Module Flex Update

Modification on the module flex

PCB modification

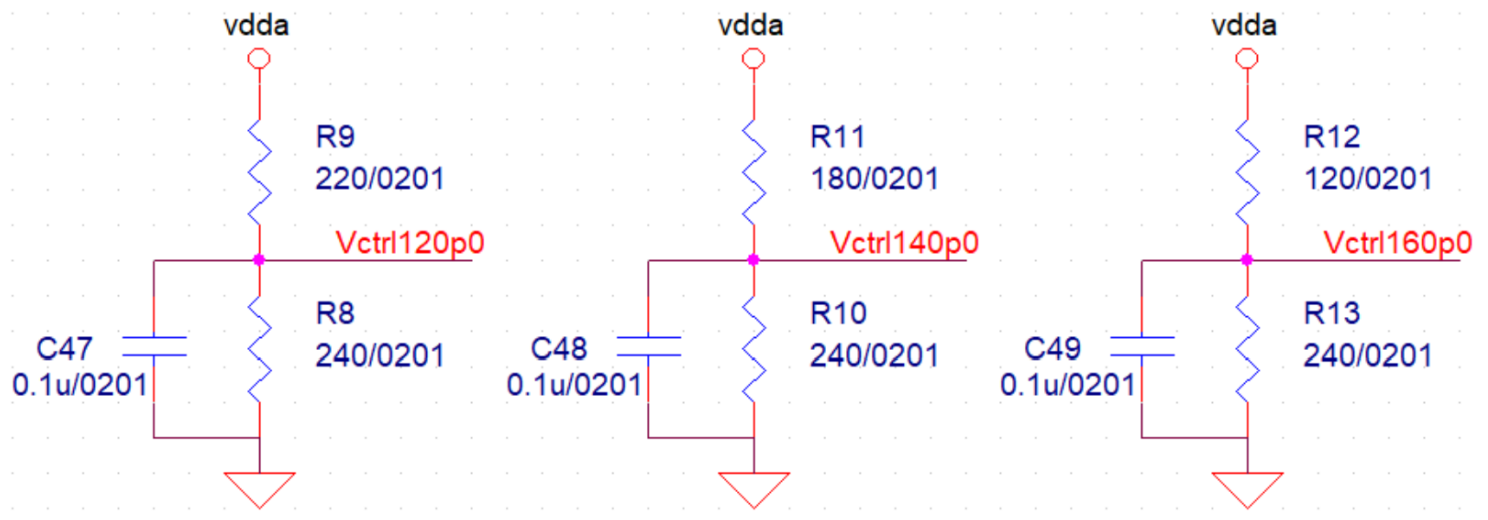
- Add 18 caps/resisters on module flex
 - 9 caps/resisters for each ASIC
 - 220 Ohm and 240 Ohm for **Vctrl120**, and 240 Ohm connects to GNDA.
 - 180 Ohm and 240 Ohm for **Vctrl140**, and 240 Ohm connects to GNDA.
 - 120 Ohm and 240 Ohm for **Vctrl160**, and 240 Ohm connects to GNDA.

Surface occupancy for caps/resisters

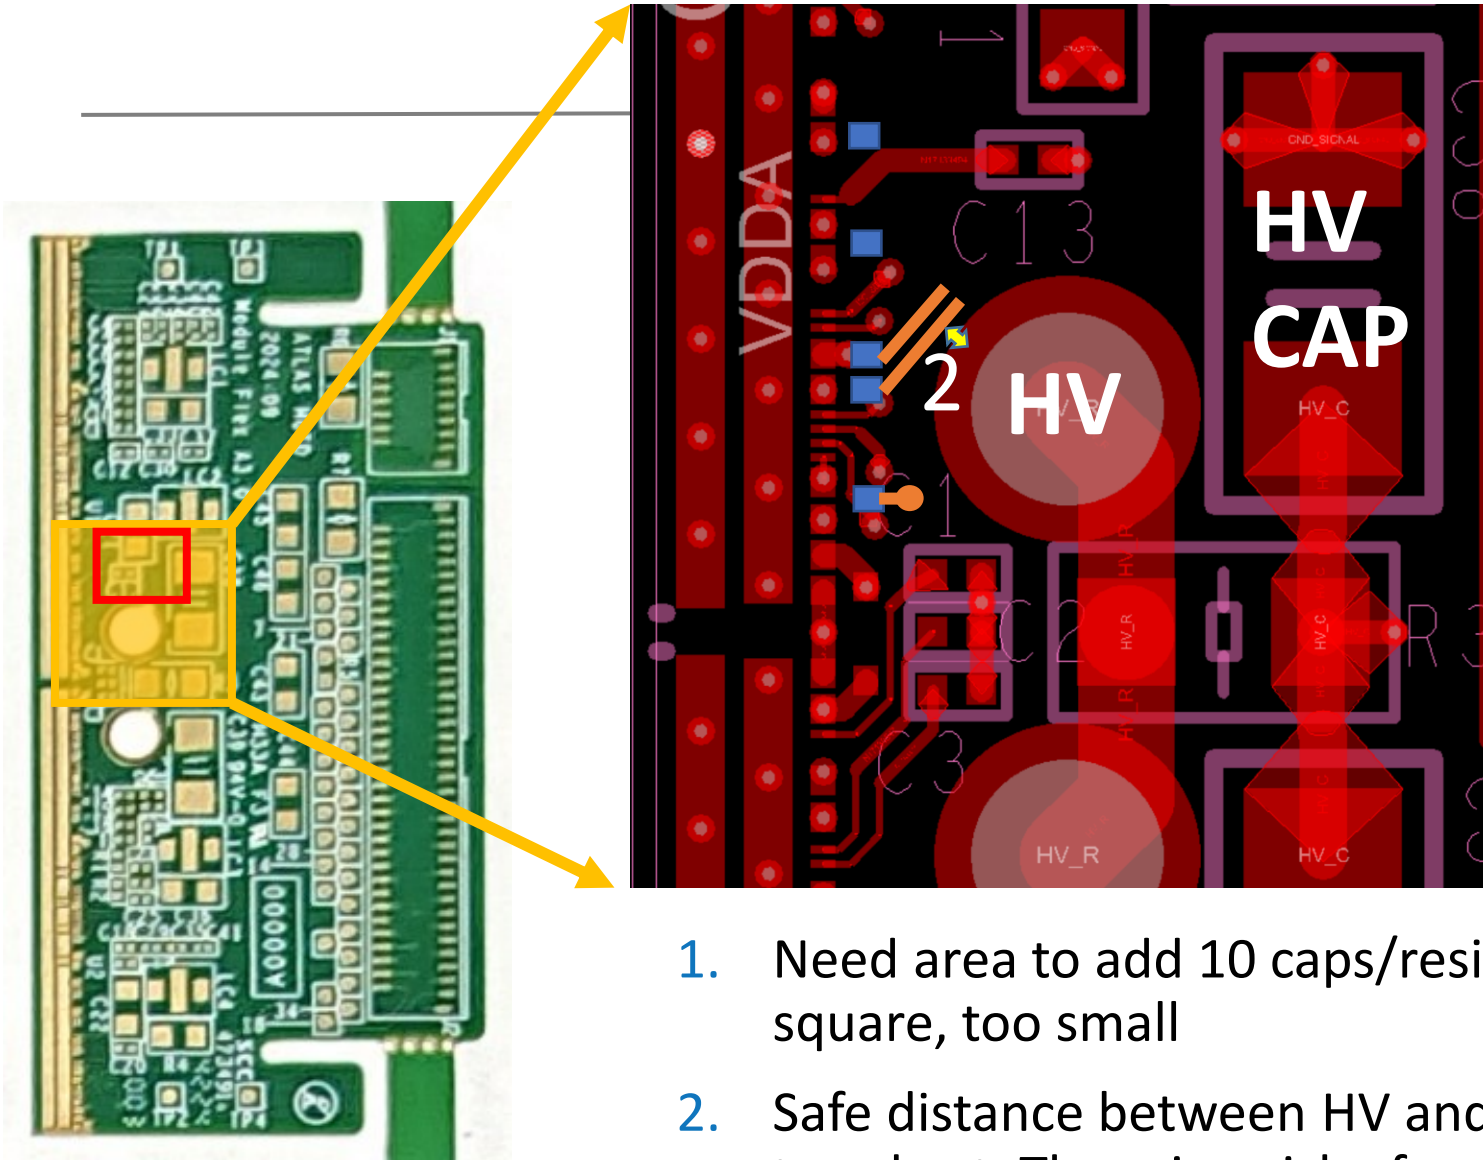
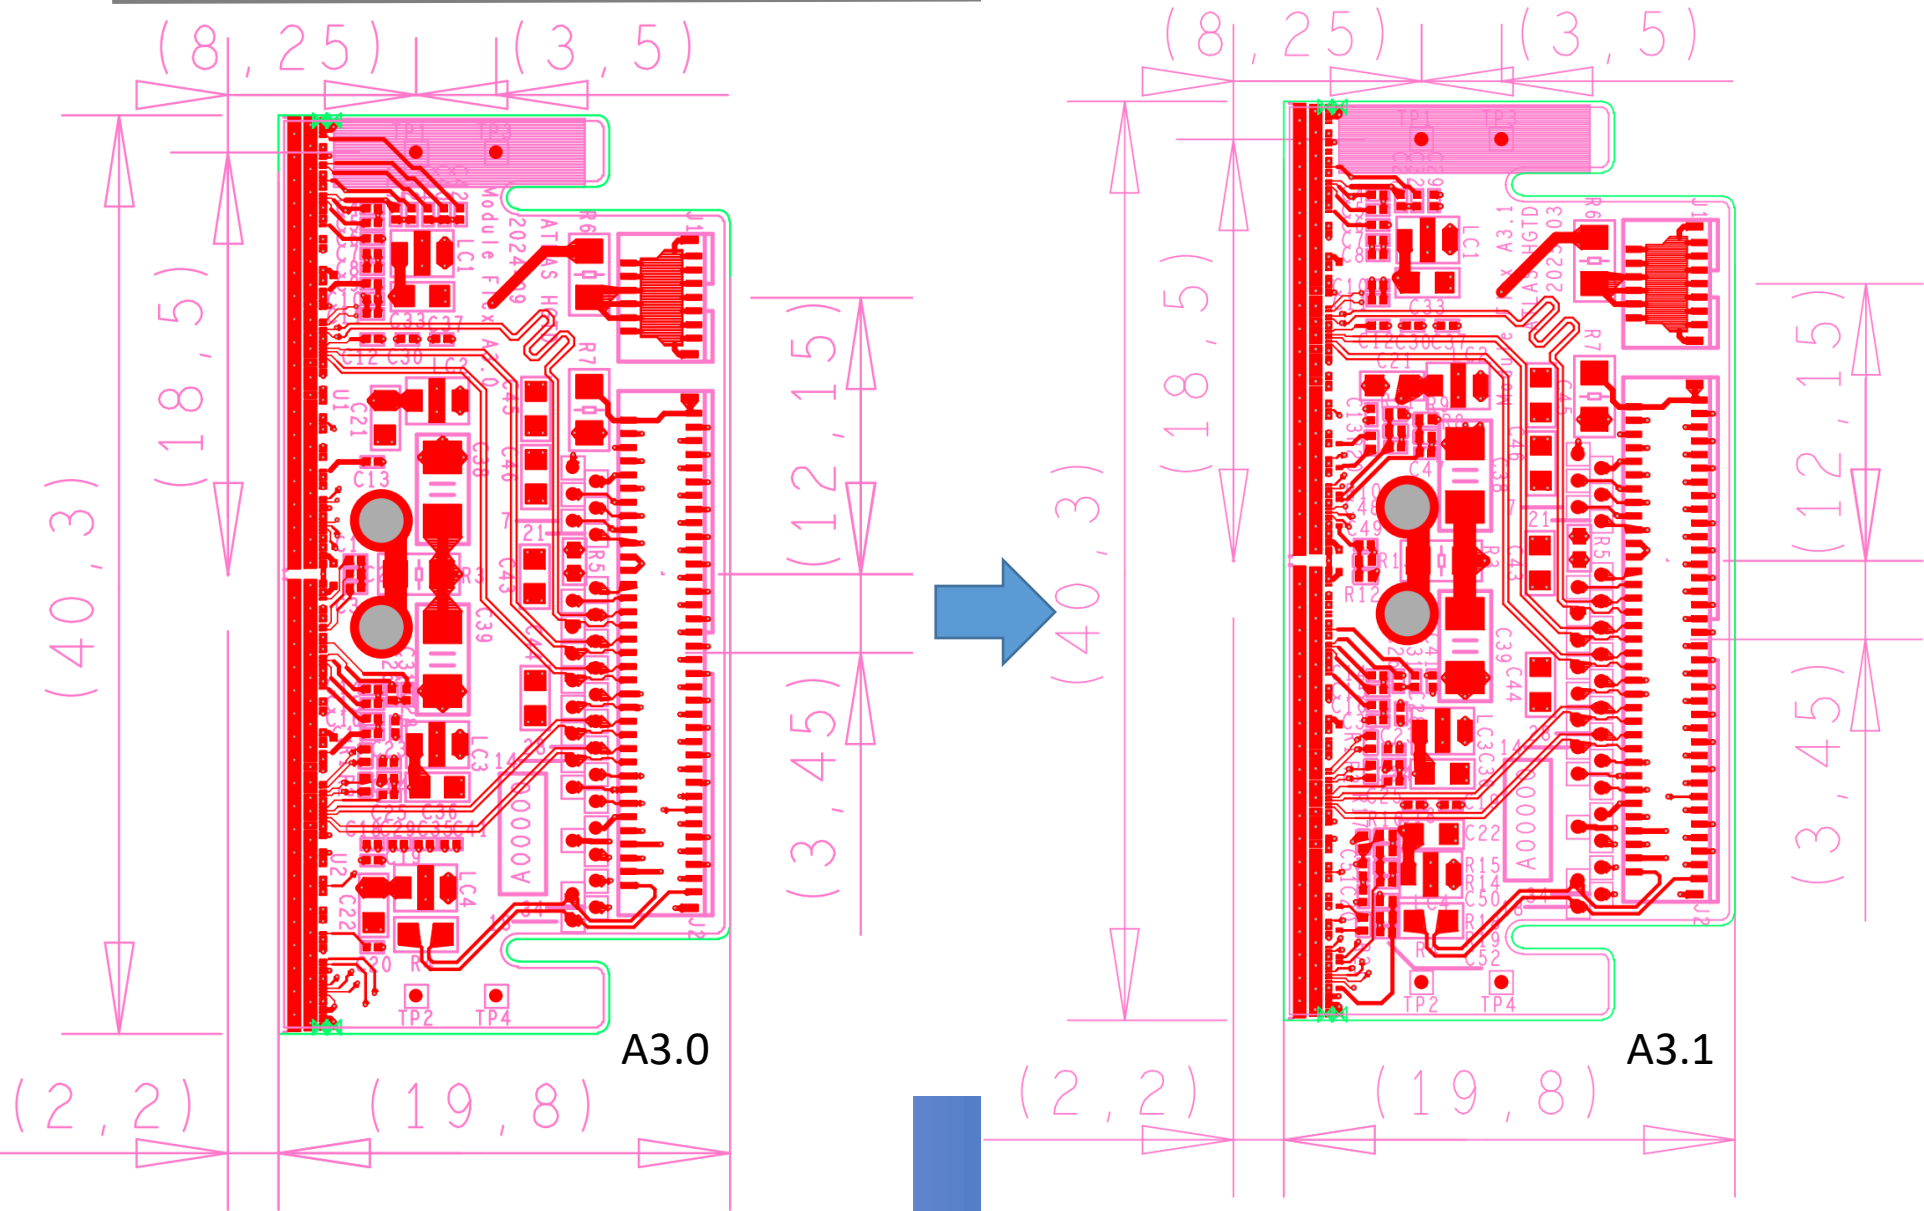
- Requested area
 - Caps/resisters size: 0201
 - Red square shows the area for 10 caps/resisters
- Orange square is the pin region to add
 - Pin 199 - windows2p
 - Pin 213 - ext-discp
 - Pin 229 - vctrl140p
 - Pin 231 - vctrl120p
 - Pin 247 – vctrl160p
 - Add the pad at the fourth column
- Other Caps changes
 - Caps for vcasc_pa, vcasc_disc, vbi_disc, vbo_disc removed
 - Cap for c_ext_por reserved
- For WB
 - Remove 4 wires
 - Add 5 other wires
- Blue circles are pick up areas for jig or SU
 - Keep as the same as before

1. Need area to add 10 caps/resisters in the red square, too small
2. Safe distance between HV and the routings are too short. There is a risk of spark discharge.

Modification on Placement

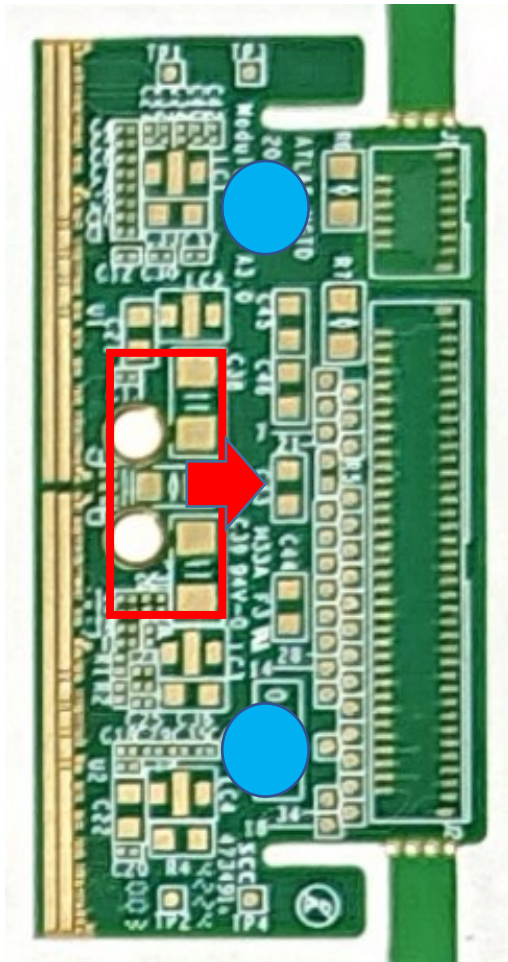
- Move HV caps, resistor and HV WB holes to right side by 0.75 mm.
 - Influence on DU design
- No changes on pick-up area
